APPLICATION FOR WITHHOLDING PROPRIETARY
INFORMATION FROM PUBLIC DISCLOSURE

SUBJECT: RCS Flow Measurement Uncertainty

RAI 492.6 (4.4)

FIGURE 3.2-3
RCS TOTAL FLOW RATE VERSUS R_1
FOUR LOOP OPERATION

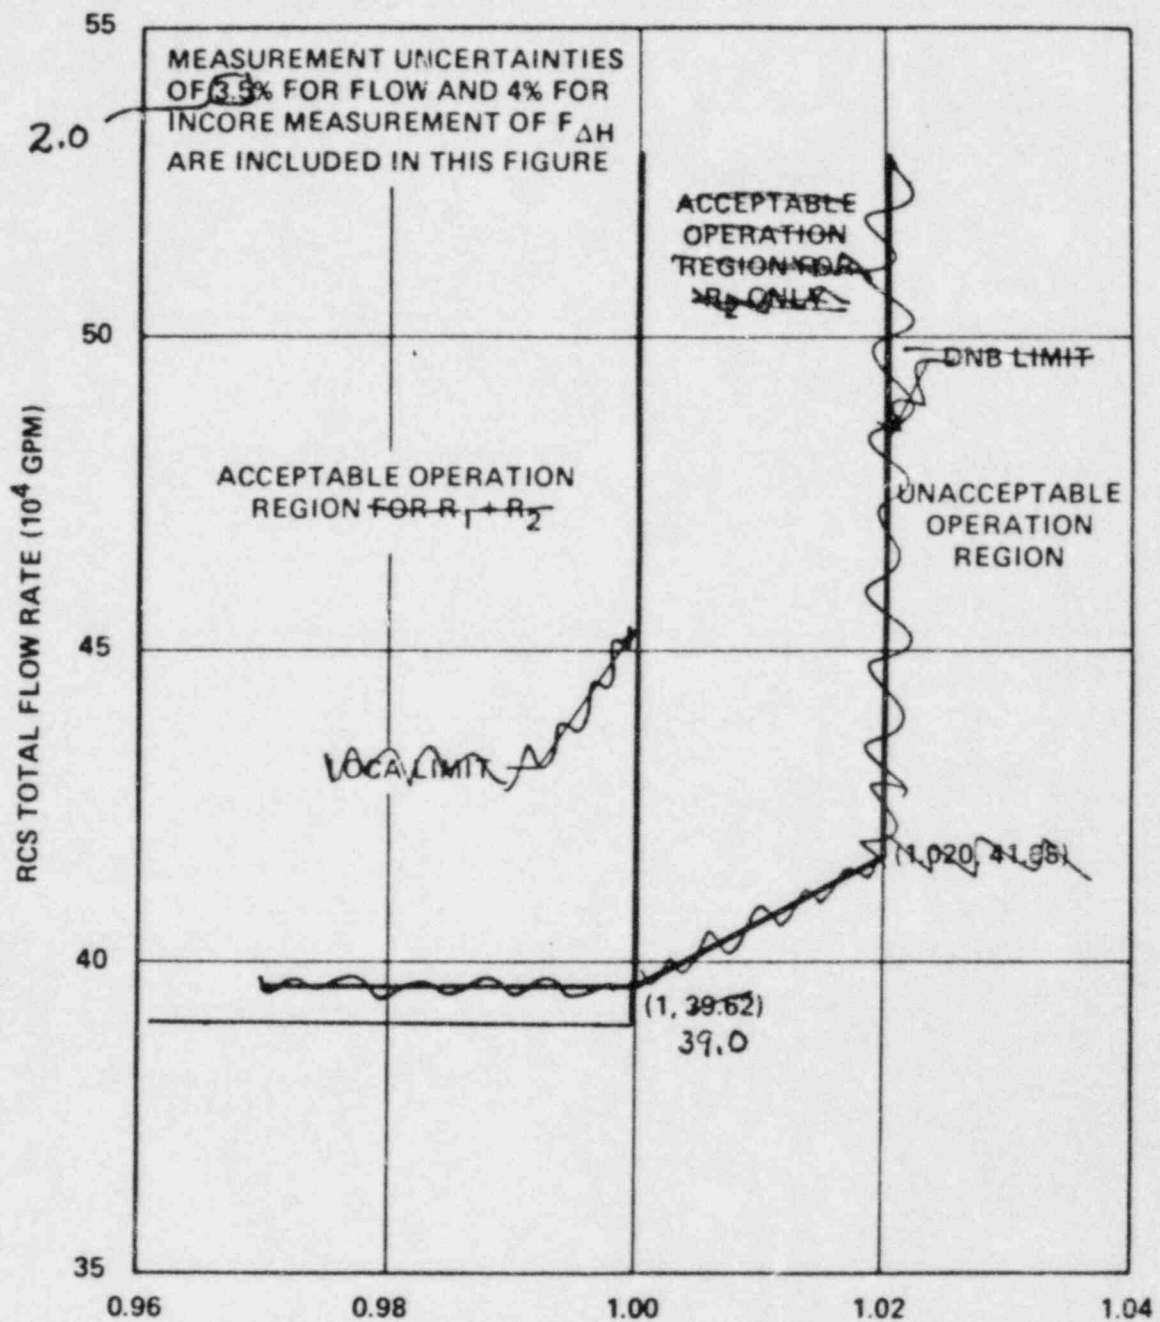
3.2.3 The combination of ~~Vaporizer~~ ~~Reactor Coolant System~~ ~~VCA~~ total flow rate and R_1 shall be maintained within the region of allowable operation shown on Figure 3.2-3 for 4 loop operation.

With the combination of RCS total flow rate and R_1 outside the region of acceptable operation shown in Figure 3.2-3:

4.2.3.3 The ~~indicated~~ RCS total flow rate shall be verified to be within the region of acceptable operation of Figure 3.2-3 at least once per 12 hours when the most recently obtained values of R_1 and R_2 , obtained per Specification 4.2.3.2, ~~are~~ assumed to exist.

FIGURE 3.2-4
ROD BOW PENALTY
AS A FUNCTION OF BURNUP

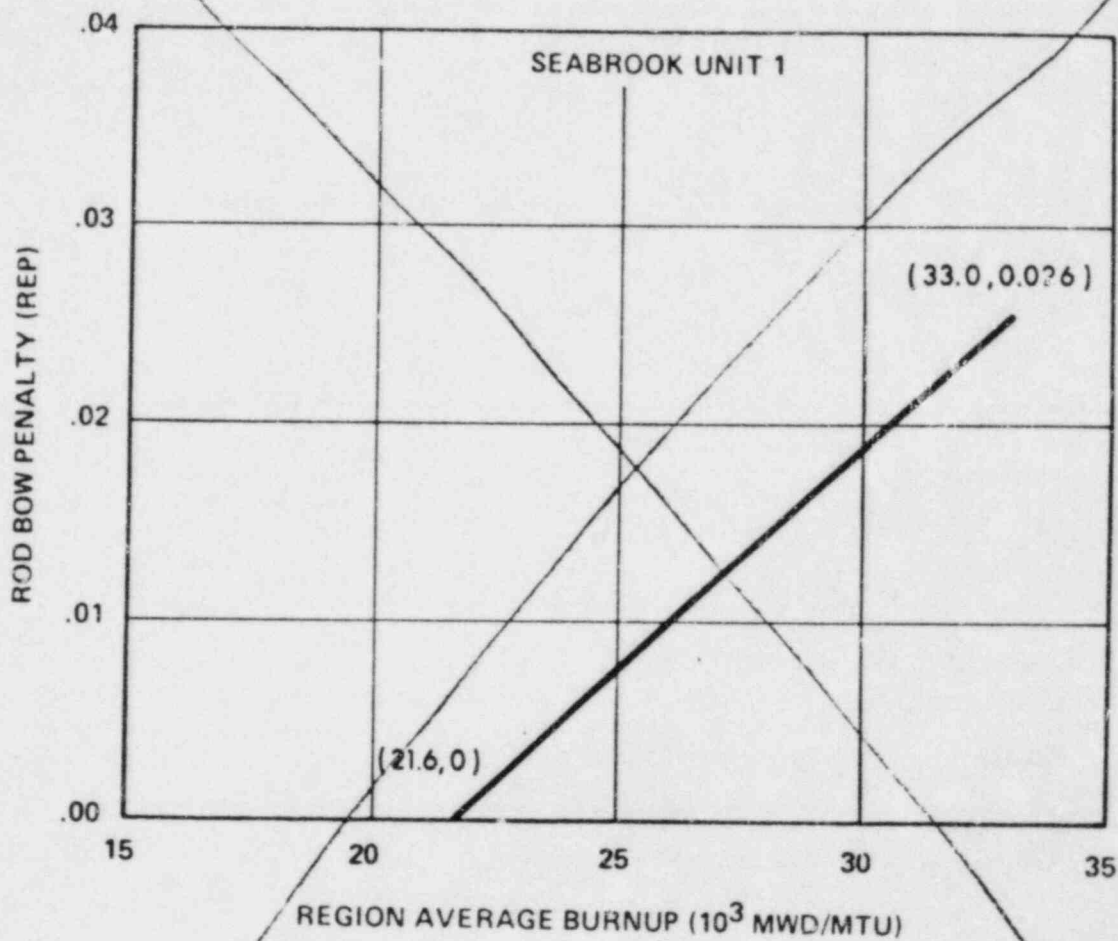
The Topical Report WCAP-8691, Revision 1, "Fuel Rod Bow Evaluation", has been approved by the staff. If you plan to reference this, you are requested to provide a new table of rod bow DNBR penalty vs. fuel burnup based on the approved method which will be used in the Technical Specifications.

~~$RBP(BU)$ = Rod Bow Penalty as a function of region average burnup as shown in Figure 3.2-4, where a region is defined as those assemblies with the same loading date (reloads) or enrichment (first core).~~

We do intend to reference the Topical Report WCAP-8291, Revision 1. Accordingly FSAR Sections 4.2 and 4.4 were revised in Amendment 53. Technical Specifications 3/4.2.3 and BASES 3/4.2.3 will be revised. We have attached a copy of Amendment 53 that is marked-up to correct a typographical error and to provide clarification and a draft copy of the Technical Specification change.
